INDEPENDENT STRUCTURAL ANALYSIS FOR THE CORPUS CHRISTI NEW HARBOR BRIDGE PROJECT

TECHNICAL MEMORANDUM

TOWER DRILLED SHAFTS

DOCUMENT NUMBER: TM1001

Figure 1: Foundation Cap 1NT, Foundation Cap and Shaft Layout, Drawing NHB-30A (by Others)

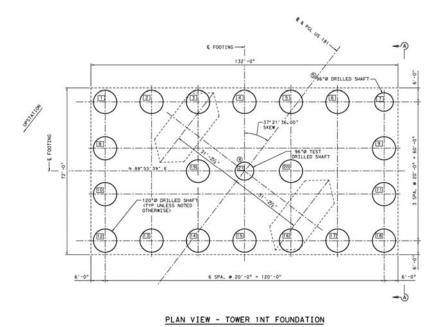
The foundation elements that support the main towers are identified as 1NT and 1ST. Foundation 1NT includes a total of 19, $10'\phi$ drilled shafts and 1, $8'\phi$ drilled shafts (middle test shaft is not part of the functional foundation). Foundation 1ST includes a total of 20, $10'\phi$ drilled shafts. The tower is skewed to the foundation by a ~37.4° angle, which leads to a non-orthogonal positioning between the tower and foundation shaft group. The foundation cap is 132'-0'' wide, 72'-0'' long, and 18'-0'' deep.

AASHTO LRFD §10.5.1, §10.5.5.2.4, and §10.8.3.5 specify the requirements for computing the geotechnical axial capacity of drilled shafts to resist the calculated demands. This technical memorandum focuses on the geotechnical axial capacity under compression Strength loading. Using the code provisions listed above, the ISA identified multiple drilled shafts that are under capacity, indicating a serious deficiency in the foundation design.

Figure A1: ISA 90-deg Wind STR 3 Load Combination – 1.05 Factor

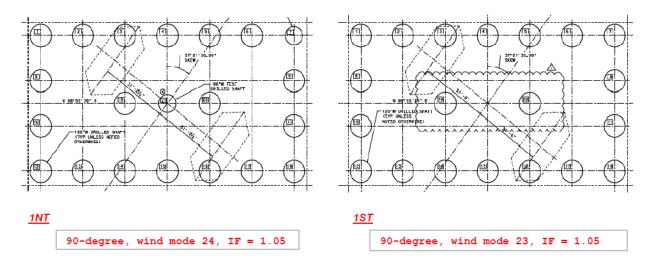
- o Foundation 1NT, ISA Maximum Shaft Load = 17,159 kips, D/C = 1.30
 - o Foundation 1ST, ISA Maximum Shaft Load = 18,431 kips, D/C = 1.22
 - Foundation 1ST, DLE Maximum Shaft Load = 17,857 kips, D/C = 1.18

Figure A5: ISA 270-deg Wind STR 3 Load Combination— 1.05 Factor

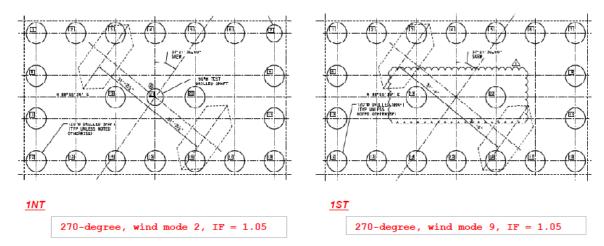
- Axial Strength load demands on the drilled shafts, per AASHTO defined load combinations with an Importance Factor of 1.05 and 270-deg wind:
 - Foundation 1NT, ISA Maximum Shaft Load = 17,484 kips, D/C = 1.32

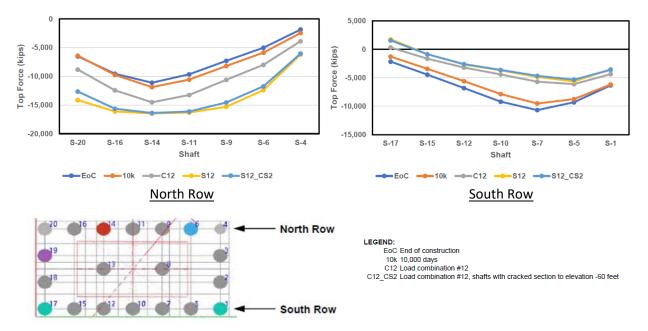
If the determining qualitative observations of this paper were applied to the 1NT and 1ST foundations, the shaft load distribution most closely resembles the non-rigid results presented in the paper. The figures below were taken from Duan and McBride and show plots of the pile loads under the different cap thicknesses. In the non-rigid behavior, a dishing effect in the pile load distribution is clear.

The concentration of the shaft load distribution occurs under the tower legs, and the same dishing behavior documented in the Duan and McBride paper can be visually identified in these plots. In addition, the dishing is asymmetric within the foundation and resembles Figures 7 and 8 of the Duan and McBridge paper. Clearly the criteria to classify a non-rigid foundation in the paper applies to the 1NT and 1ST foundations.
